T-13929

Groundwater Transfer Review Summary Form

Transfer/PA # T- 13929

Application: T-13929

Groundwater Transfer Application T-13929

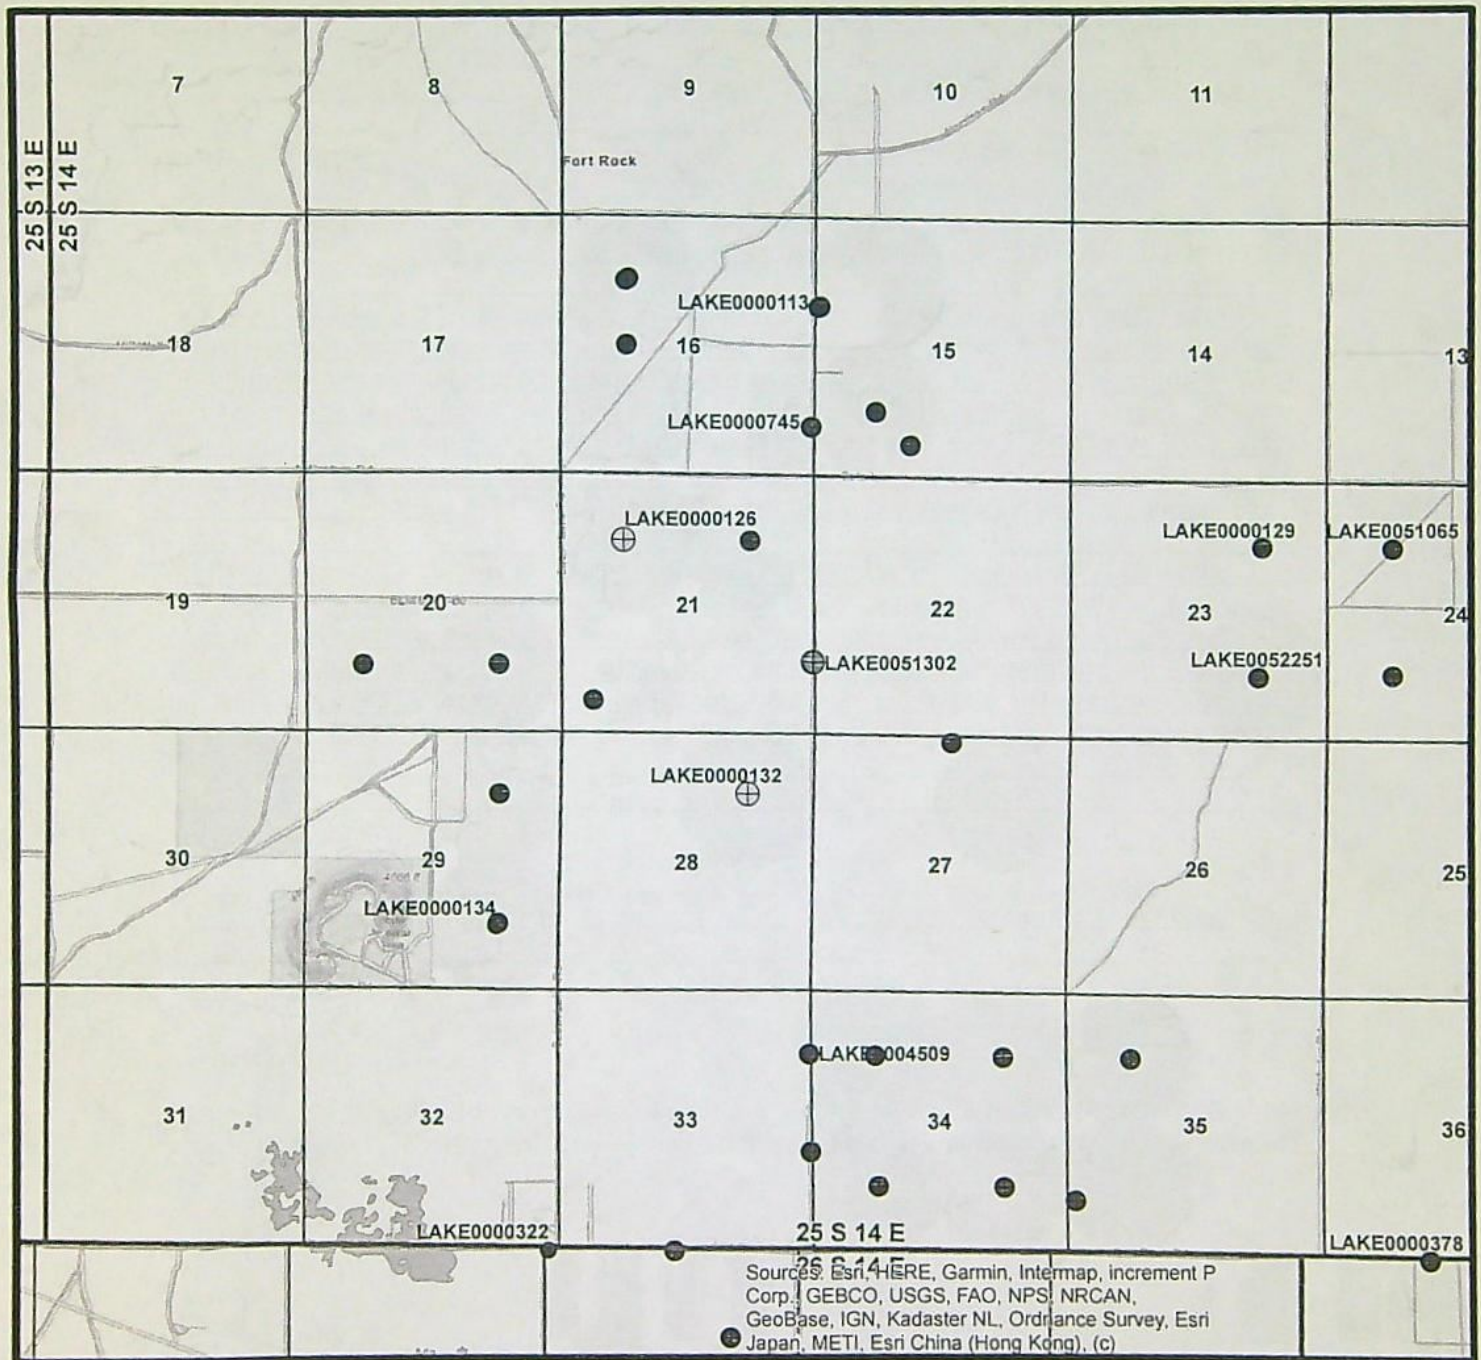
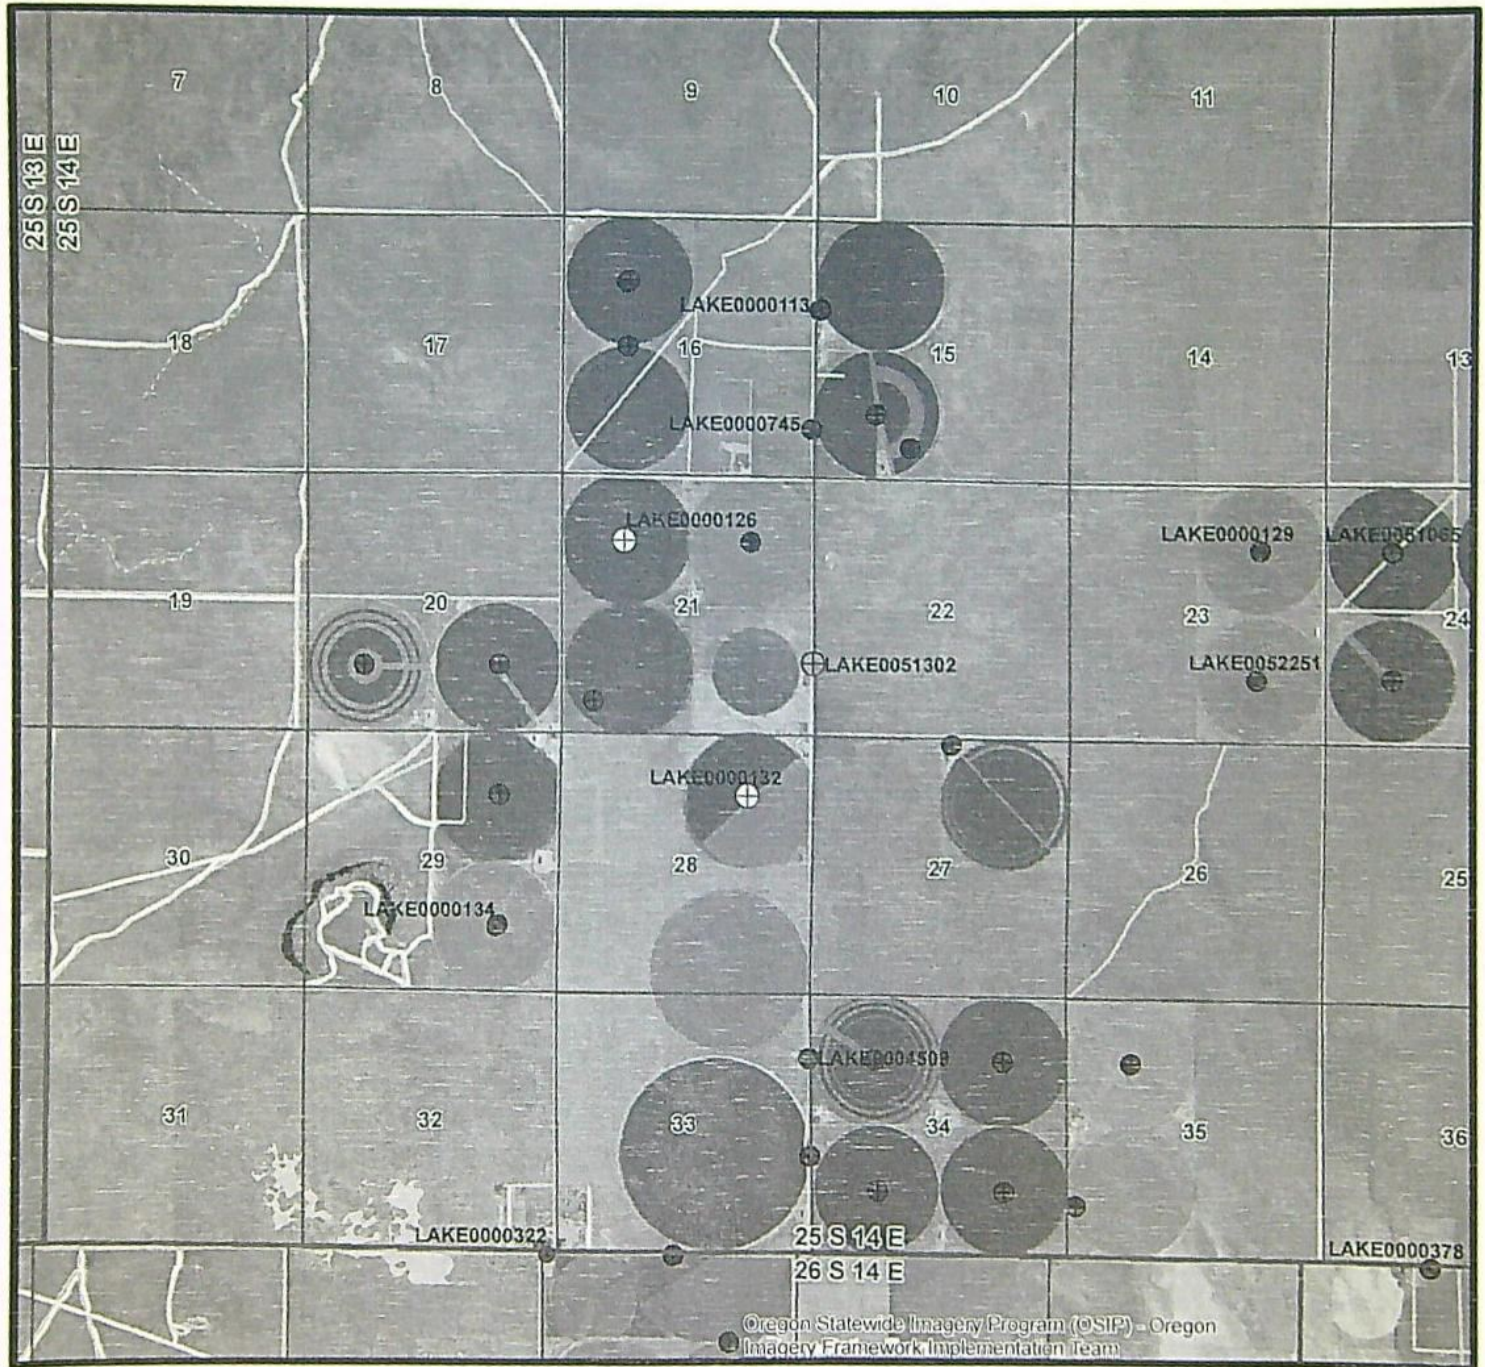
This transfer application relates to two water right certificates (52644 & 52642). The transfer application proposes moving two POU segments (21.0 acres total: 2.0 acres and 19.0 acres respectively) within T25S/R14-sec 21 & 28 to a single POU center pivot within T25S/R14-sec 21 and transferring related groundwater pumpage (0.26 cfs total = 117.82 gpm total) from two POA/POD wells within T25S/R14-sec 21 & 28 to a single POA/POD well within T25S/R14-sec 21 as shown in attached maps.

Essentially yes, the "same aquifer" (source) given the same groundwater system will likely be tapped despite the authorized and proposed POA wells are constructed to varying depths and tap varying geologic units (see attached well logs). Long term groundwater level data indicates groundwater levels at wells in the vicinity of the currently authorized and proposed POA locations have similar elevations, seasonally fluctuate similarly, and show the same long-term trends (see attached hydrograph) despite being completed at varying depths and different geologic units.

The proposed POA well change will move groundwater pumping closer to the same groundwater right POA well within T25S/R14-sec 21. The calculated maximum additional seasonal groundwater level drawdown at that POA well is less than 0.20 feet. That POA well should be able to accommodate the seasonal drawdown change. The maximum additional seasonal groundwater level drawdown at other POA wells further away will be less.

No. The POA changes moves the net pumping further away from Paulina Marsh and Silver Lake. The seasonal drawdown at Paulina Marsh and at Silver Lake is calculated to be the same to less than current. The long-term interference should be the same.

"Large" flow meter condition for any proposed "To" POA and/or APOA well. Require the flow meter for any POA and/or APOA well to be properly installed and maintained. Each meter shall be either within 50 feet of the well head with a clearly visible monument adjacent to the meter or a surveyed location shall be provided and a clearly visible monument adjacent to the meter shall be installed for each meter more than 50 feet from the well head.

Condition 7P (well tag condition) for all the "To" and "From" POA wells.

Condition 7T (modified) for all "To" POA wells: "Prior to use, all POA wells shall be configured to allow a strictly clean water (no oil) static water level measurements with an electric-tape. That can include measurement access via an unobstructed vertical discharge pipe that allows the groundwater level to fluctuate freely within the discharge pipe (no valves, etc.). Otherwise, a dedicated measuring tube must be installed prior to use. The tube must be unobstructed, have a diameter of 3/4 inch (0.75 inch) or greater, and pursuant to figure 200-5 in OAR 690-200."
